**NORTH VALLEY SUBDIVISION
GENERAL PROJECT REPORT**

FILE: #35-94
DATE: March 17, 1994
STAFF: Kathy Portner
REQUEST: North Valley Subdivision--Preliminary Plan
LOCATION: 24 3/4 Road, north of G Road
APPLICANT: G Road LLC

TITLE HEADING: Preliminary Plan - North Valley
Subdivision

**NORTH VALLEY SUBDIVISION
PRELIMINARY PLAN
FILE #35-94
24 3/4 ROAD & "G" ROAD**

**NORTH VALLEY
SUBDIVISION
PRELIMINARY PLAN**

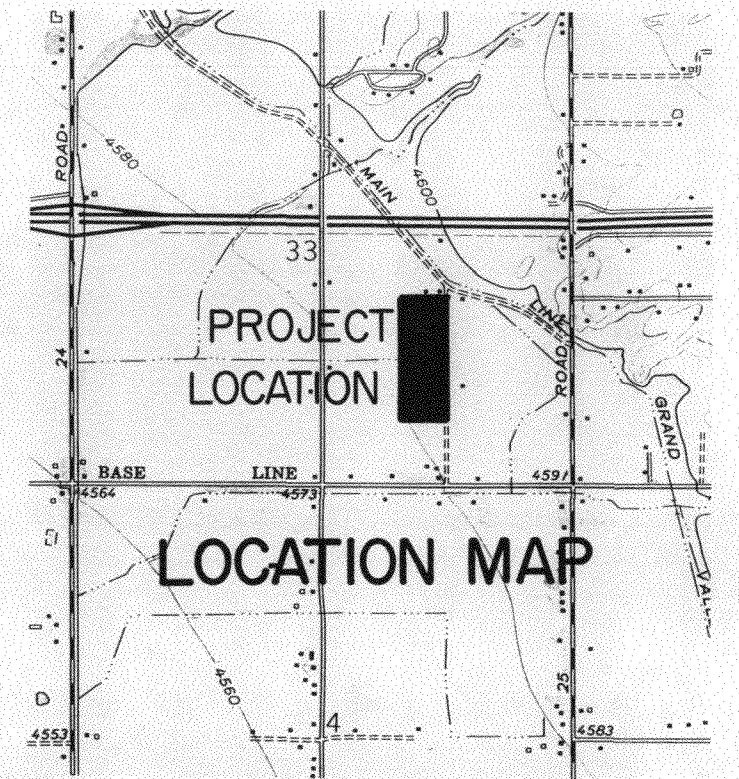
The proposal is for preliminary plan approval for 74 lots on 20 acres for an overall density of 3.7 units per acre and an average lot size of 9,000 square feet. The property is not yet in the City limits and currently has a zoning of Planned Residential (PR) not to exceed 17 units per

acre. The petitioner is proposing to have lots access directly onto 24 3/4 Road which is acceptable as a residential collector. Allowing lots to front onto 24 3/4 Road will greatly improve the appearance of the corridor. This property was originally a part of the Fountainhead Subdivision and the assessor's map shows Fountainhead Blvd. as being platted through the property. However, the petitioner has indicated that plat has been vacated and there is no Right-of-Way to be vacated with this submittal. That will have to be verified before final.

1. After further discussion with City Staff we must require that there be a east-west connection through the property that intersects with the platted Fountainhead Boulevard at 24 3/4 Road. The alignment through the North Valley Subdivision does not have to be a straight line.
2. A street stub to the north must be provided, preferably through lots 21 and 22.
3. A street stub to the west must remain.
4. Half street improvements along 24 3/4 Road will be required for the entire length of the property with the first plat.
5. The attached Power of Attorney (POA) for annexation must be completed and signed for the annexation of the property to proceed.

1) We agree that some type of road continuation to the west is desirable. However, after numerous discussions we aren't sure that a direct continuation of the "old" Fountainhead Boulevard is the most desirable solution. In our opinion, long continuous traffic flow patterns thru residential neighborhoods should be discouraged for safety reasons. The new Sports Complex area will add additional traffic thru the area and a straight shot along a road from 24 1/2 to 25 Road may not be desirable.

Stubbing a connection to the north thru lots 21 and 22 seems to be the most logical but further investigation and topographical survey will be needed.

- 1) As noted in the answer for the City Development Engineer, we agree that an east-west connection thru the property is desirable but we do not believe that an extension of the "old" Fountainhead Boulevard is necessarily the best solution.
- 2) Stubbing a connection to the north thru lots 21 and 22 seems to be the most logical but further investigation and topographical survey will be needed.
- 3) Item noted about street stub.
- 4) As resolved per Mr. Rich Livingston and Mr. Dan Wilson, half street improvements along 24 3/4 Road will initially only be required to the northern boundary of the southern half to coincide with phased development.
- 5) Power of Attorney for annexation will be completed.
